To	Stephen Hooey - AANDC	Page 1
CC	Matt McElwaine - PWGSC	
Subject	Durban Island and Padloping Island – NWB Condition for the Provision of Landfarm Monitoring Wells	
From	Barry Fedorak - AECOM	
Date	July 17, 2013	Project Number 60214959

Amendment Application: Durban and Padloping Island

BR1-DPI1217

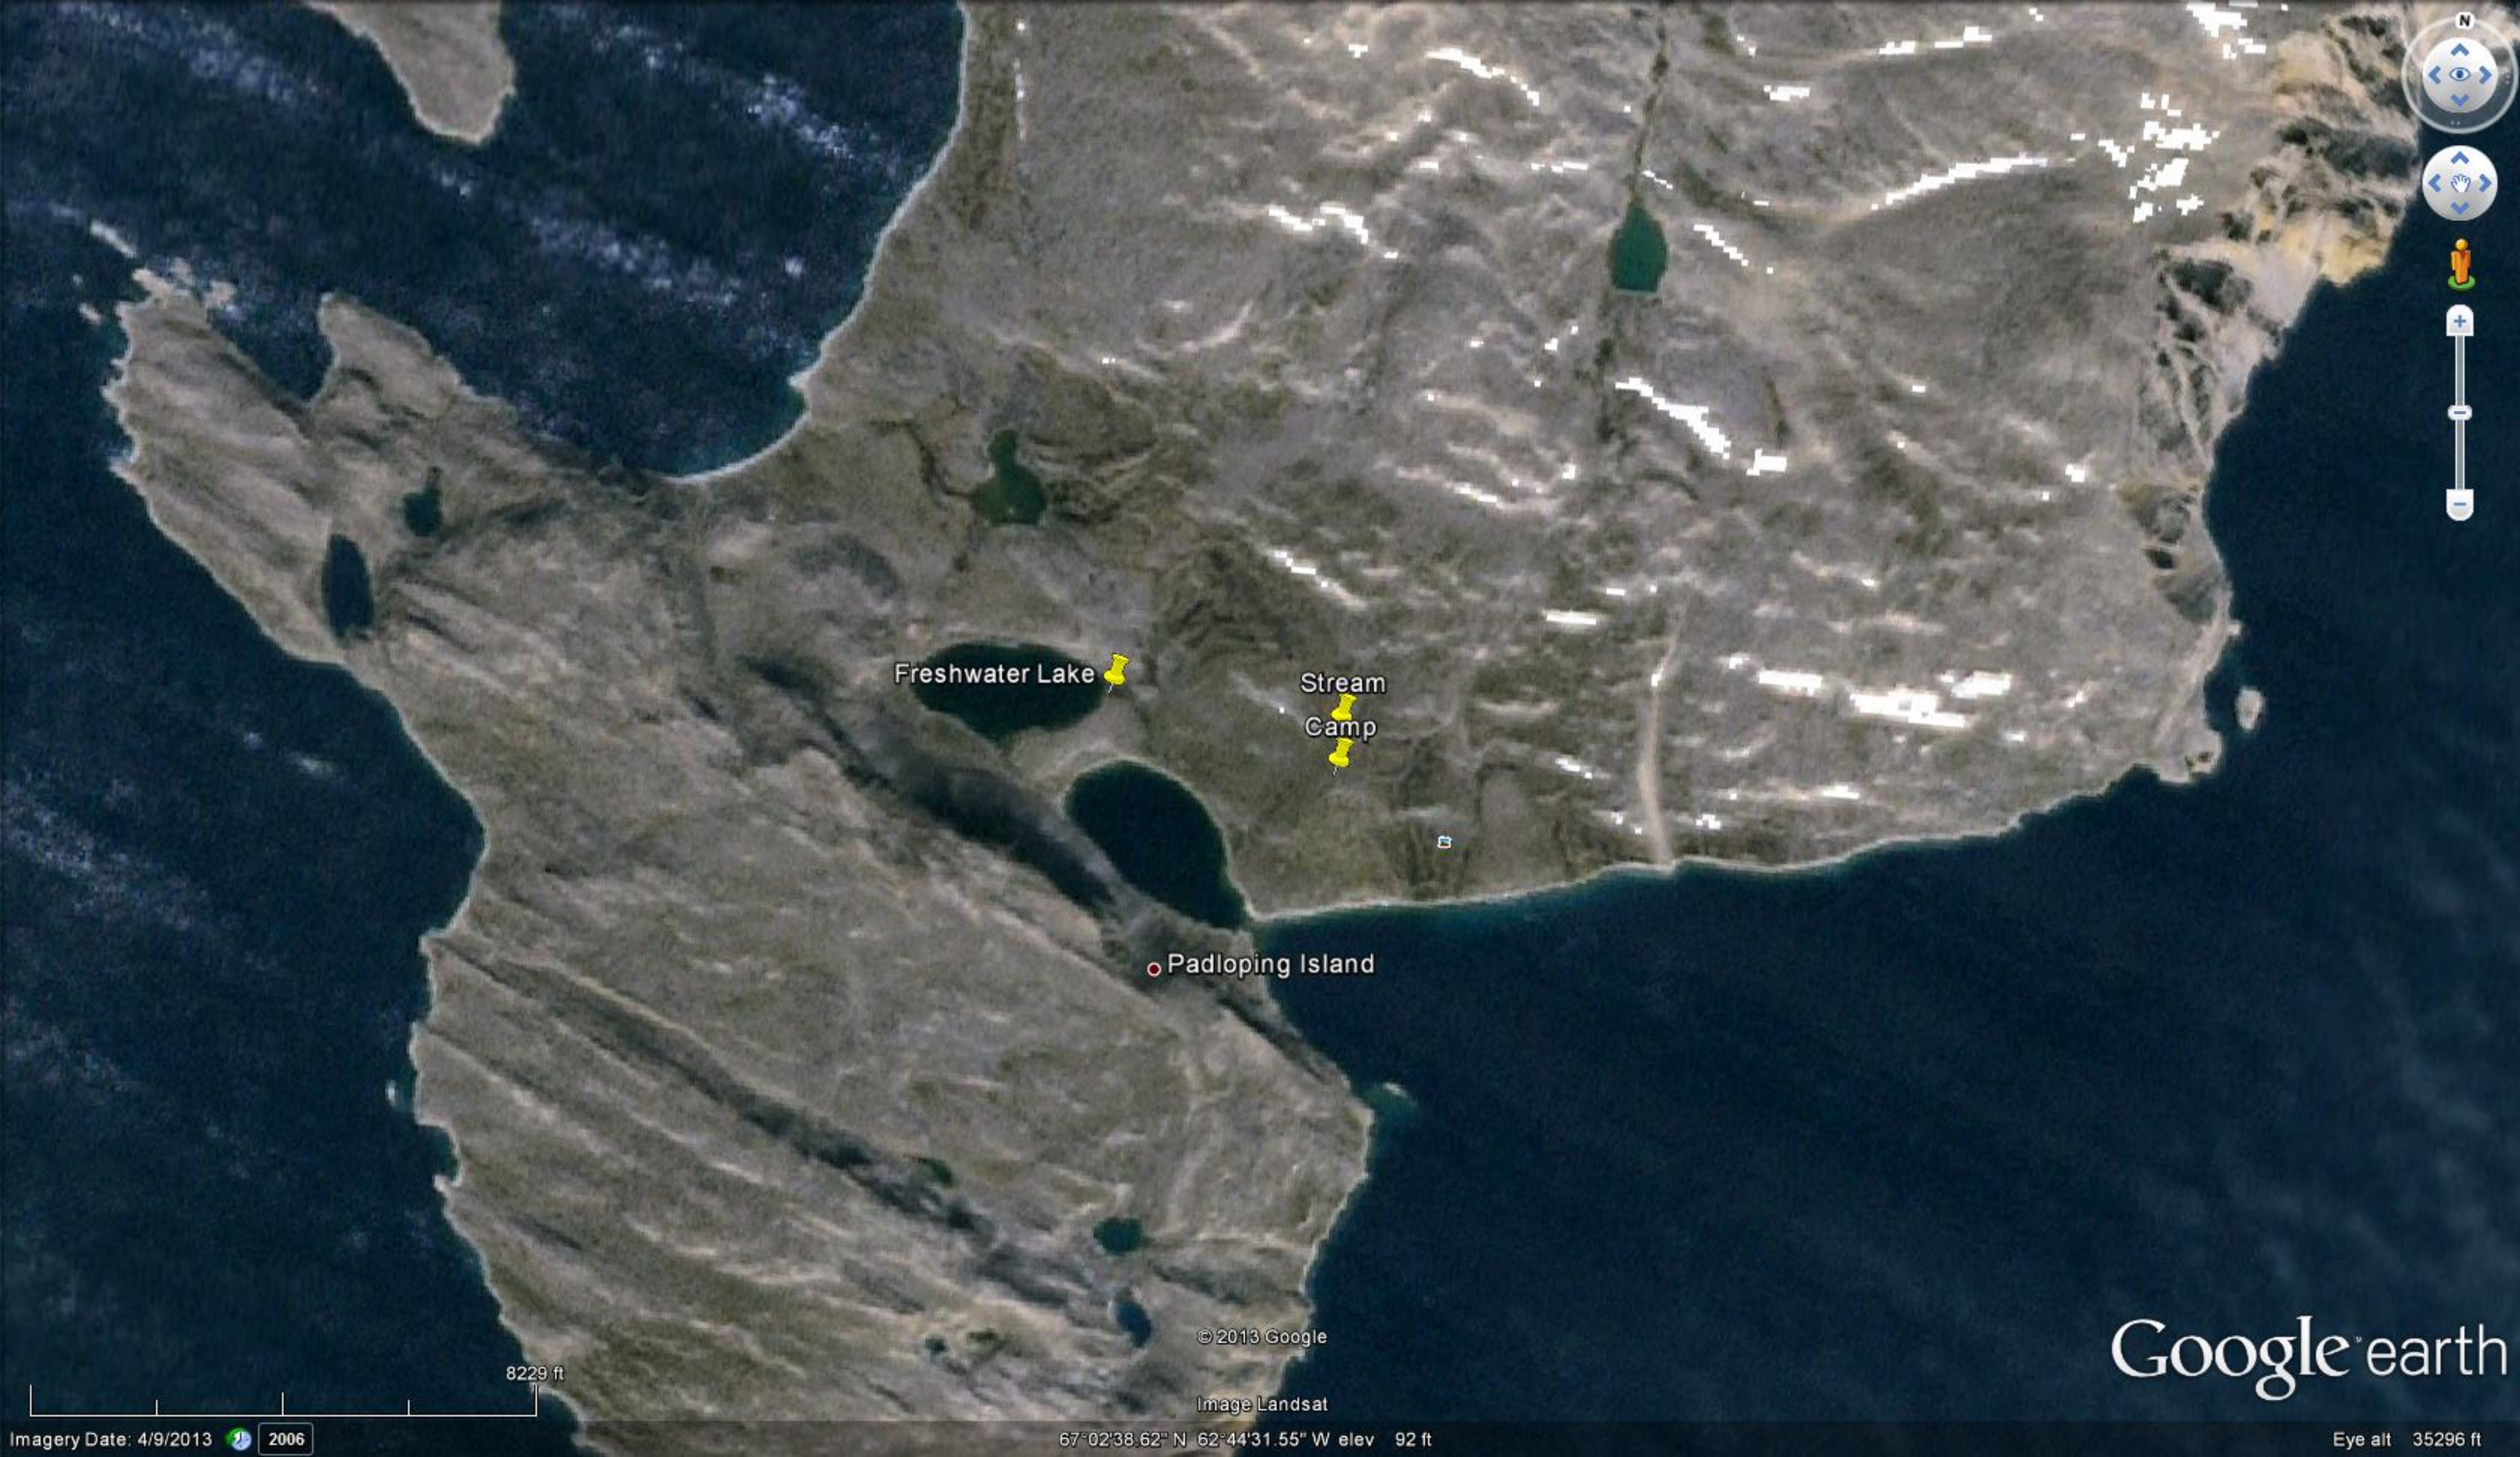
3. Water Source Change –Padloping Island

The water source originally planned cannot be accessed reliably. A small stream close to the camp will be used for water. Water usage will be less than 4 m³/day from this source.
